**Subject: Revised Site Plans – MassDEP File #301-1409
Lot 2 Brimstone Lane, Sudbury, MA**

PROPOSED STORMWATER PLAN			
APPLICANT		LOCATION	
CARRIE MACIEL		LOT 2 BRIMSTONE LANE SUDBURY, MA ASSESSORS MAP L04 & PARCEL 08	
NO.	DATE:	REVISION:	BY:
1	1/25/24	ADDITIONAL WETLANDS, REVISE SITE LAYOUT AND GRADING.	REM
CONNORSTONE ENGINEERING			
CONSULTING CIVIL ENGINEERS AND LAND SURVEYORS 10 SOUTHWEST CUTOFF, SUITE 7 NORTHBOROUGH, MASSACHUSETTS 01532 PHONE: 508-393-9727 WWW.CSEI.NET			
121 BOSTON POST RD. SUDBURY, MA. 01776 PHONE: 978-443-9566 WWW.SULLIVANCONNORS.COM			
DATE: 11/06/23		SHEET 1 OF 1

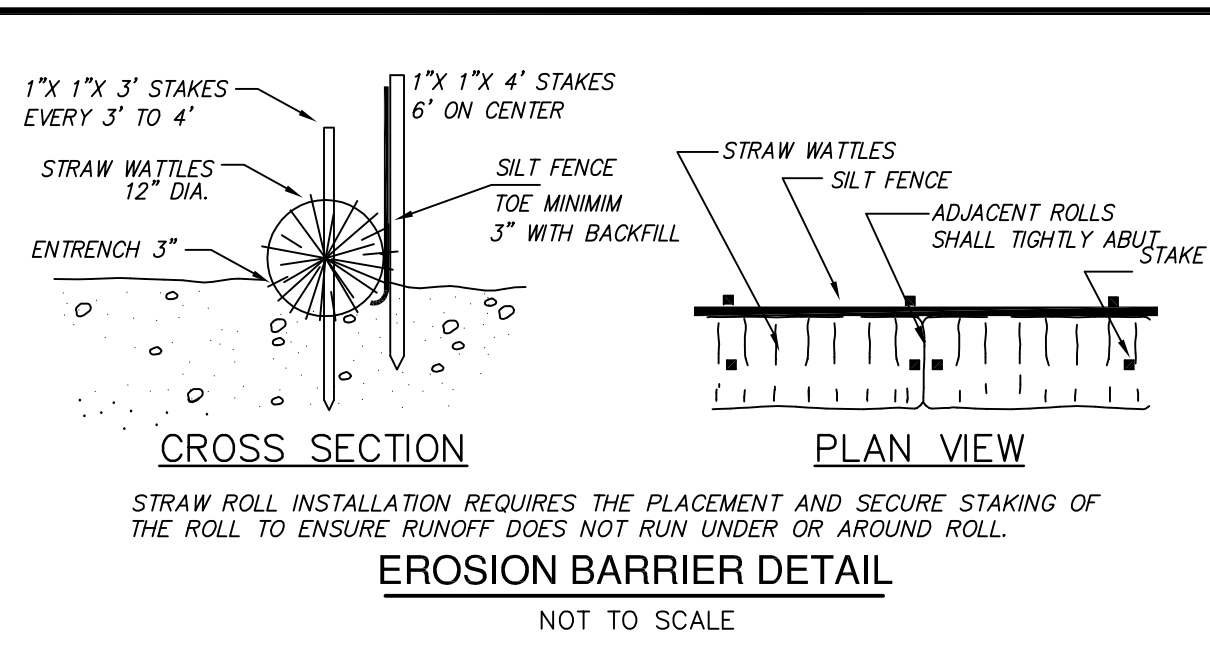
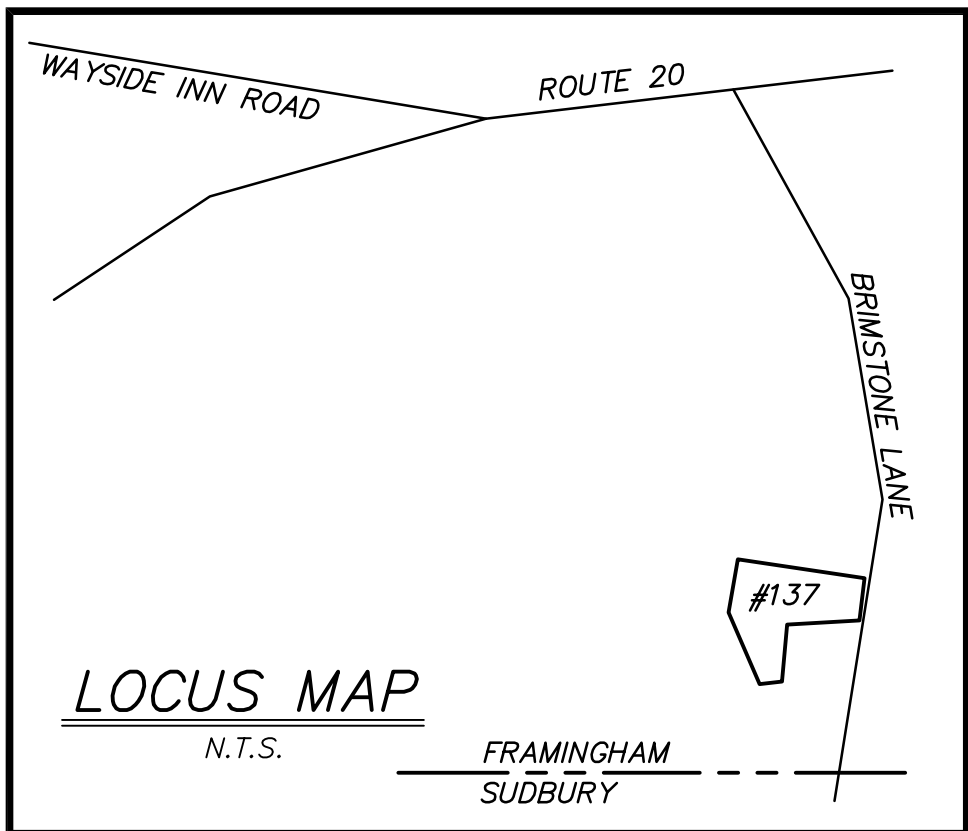
Slope Grading Alternatives: The use of retaining walls was investigated to reduce the slope grading requirements. At the rear of the septic system the top of wall would be elevation 322, and with a natural grade of 314 to 316, the wall height would range from 8 feet to 6 feet along its length. Along the edge of driveway a retaining wall would have a peak height of 12 feet. The height of walls and cost did not appear to fit the scope of a single family home. The use of riprap/stone slopes was also reviewed which would reduce grading, but would not provide the opportunity to re-vegetation with native plantings.

SITE PLAN
SCALE: 1" = 20'

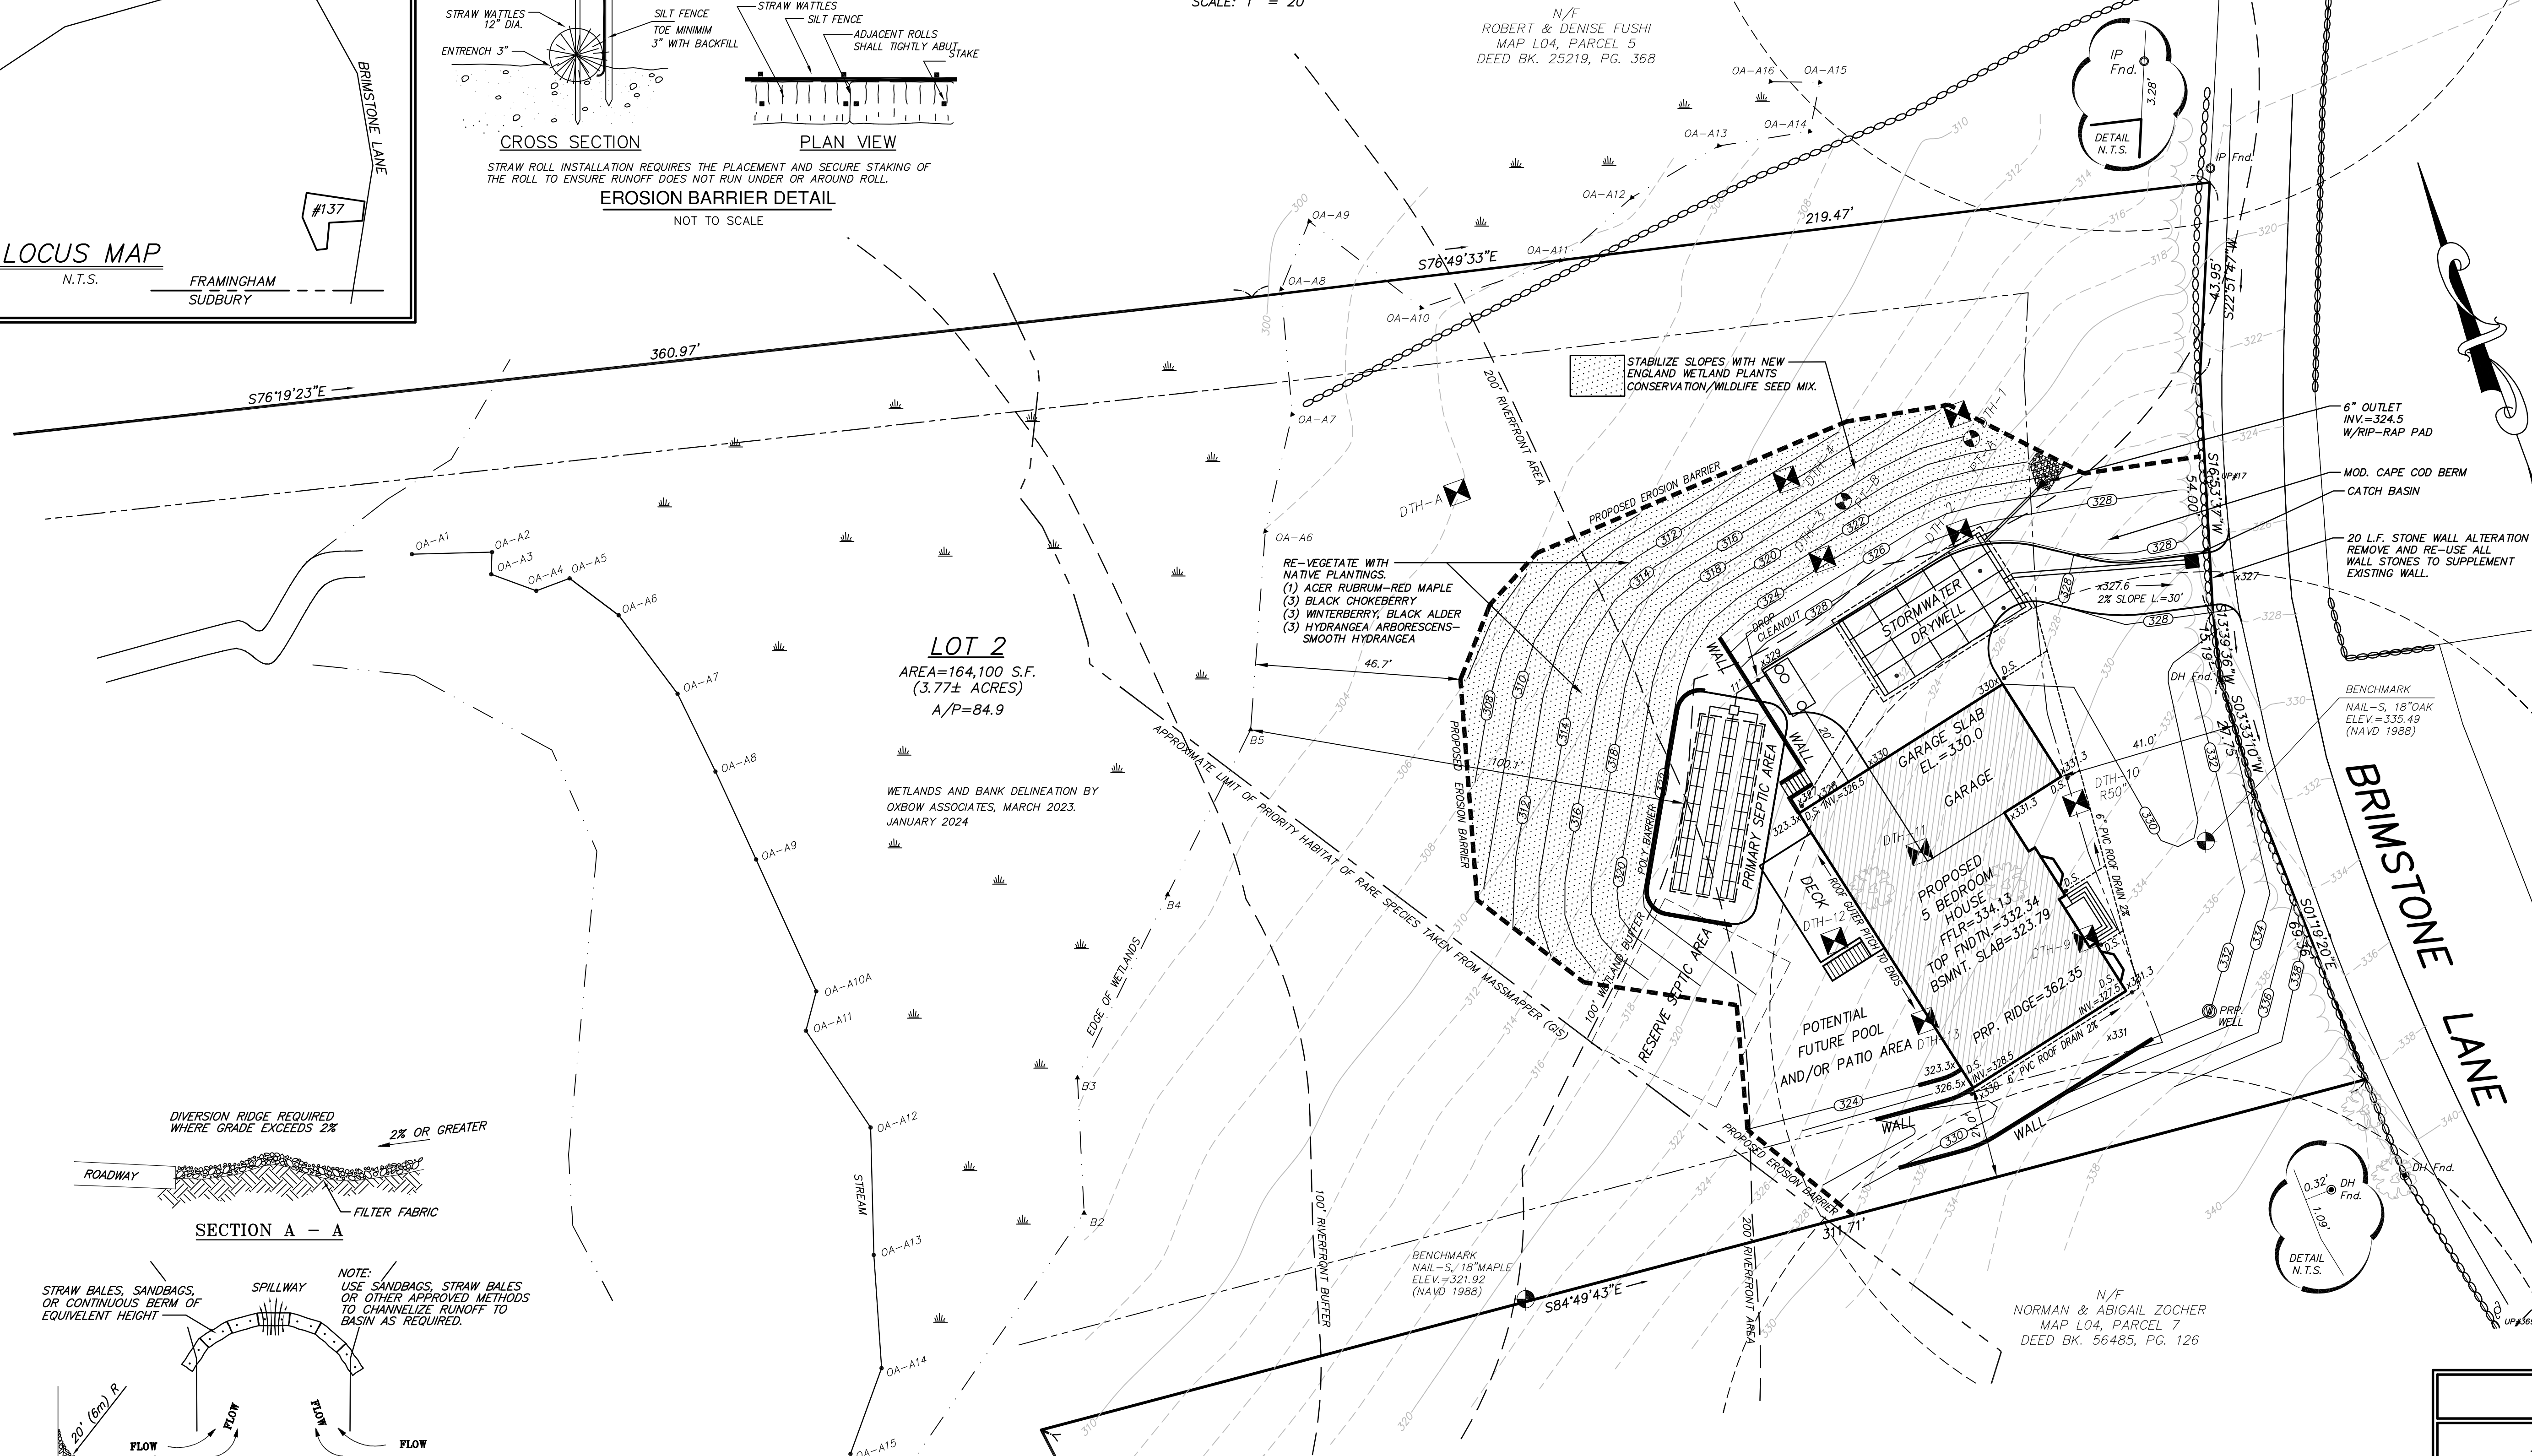
The off-site wetland resources have been delineated along the northerly property line by the project wetland scientist, Oxbow Associates. The associated 100-foot buffer zone and Adjacent Upland Resource Area extends well into the site and the previously proposed septic system area. The plans have been modified based upon the new extent of the buffer zone with the development area clustered in the southeasterly corner of the lot. The Septic system has been shown to the rear of the house outside the buffer zone. This location is conceptual and would require additional testing through the Board of Health to confirm soil conditions in the specific area.

The Stormwater Management System has also been modified based upon Commission feedback to eliminate the surface basin with the buffer zone and Riverfront Area. The updated plans have provided a subsurface drywell located under the proposed driveway. This system has been designed to offset the proposed development and mitigate the peak rate and volume of runoff from the site; provide pre-treatment of runoff; and provide groundwater recharge. The system sizing would also account for any future patio and/or pool that may be proposed in the future at the rear of the house.

100-foot Buffer Zone: The modified plans have reduced the overall site disturbance and clearing areas. Those areas to be disturbed within the 100 foot buffer zone would include vegetated slopes adjacent to the driveway and septic system. These areas would not be intended for future lawn and have been proposed to be re-vegetated with native species and allowed to become a naturalized area.

200 Foot Riverfront Area: The proposed layout has included areas within the Riverfront for vegetated slopes, most of which to be re-vegetated and naturalized, and a portion of the septic system leach field (135 sq. ft.).

- Alteration within the 100 foot Buffer Zone = 7,350 square feet
- Areas to be planted and naturalized = 6,350 square feet

- Total on-site Riverfront Area = 134,106 square feet
- 10% Riverfront Area allowable under 10.58(4)(d)(1) = 13,410 square feet
- Proposed Disturbance Area = 4,150 square feet (3%)
- Areas to be planted and naturalized = 3,350 square feet
